Generic Design Assessment – New Civil Reactor Build

Step 4 Human Factors Assessment of the EDF and AREVA UK EPR™ Reactor

Figure 3: The EDF and AREVA “iterative” Approach in Principle

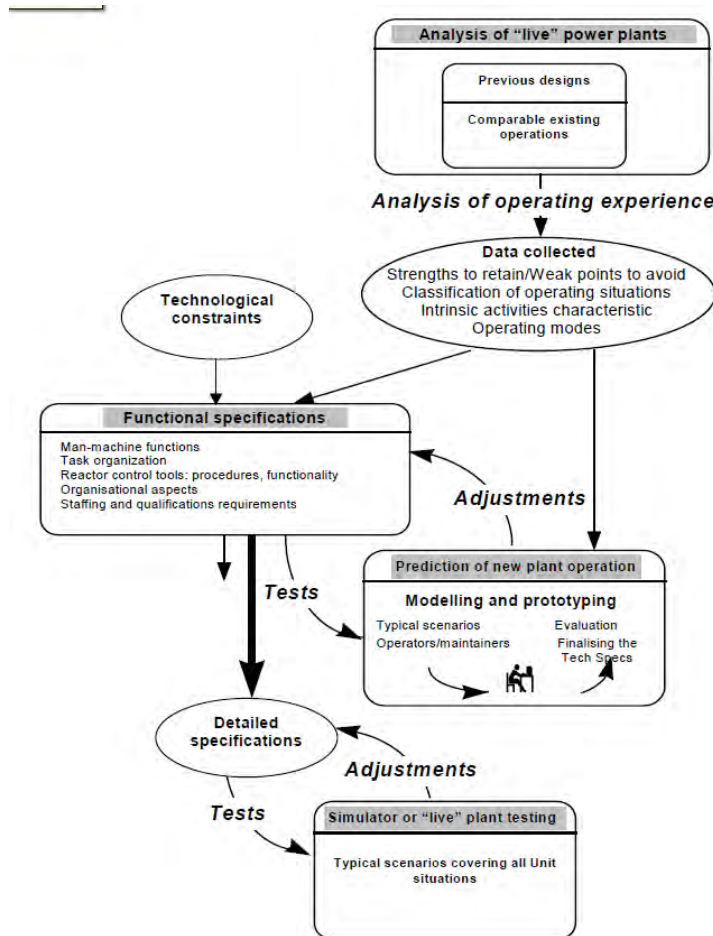
366 My initial examination of the evidence revealed that the documentation did not encompass the breadth of HFI expectations covered by the HFI TAG (Ref. 7). There is evidence of a HFE programme of work but it is largely focused on the MCR design. I have found little evidence of a fully integrated programme that actively works with other related technical disciplines in a cohesive manner to optimise the design, and from that optimisation develop and iterate the safety analysis. In addition, although the major components of a recognisable HFI programme are evidenced there are significant omissions. There has been a considerable reliance on the use of operational experience with little underpinning HF analysis. In my opinion, this does not necessarily result in an ALARP position and I have discussed this earlier in this report.

371 My assessment of Ref. 62 showed that it falls substantially short of the above requirements. However, EDF and AREVA claim an alternative approach to the HFIP where HF good practice is encapsulated within their various design specification documents, which mitigates the requirement for an integration management document such as an HFIP. These requirements are essentially embedded in the various design guidance and requirement documents applied at various points in the process shown in Figure 3.
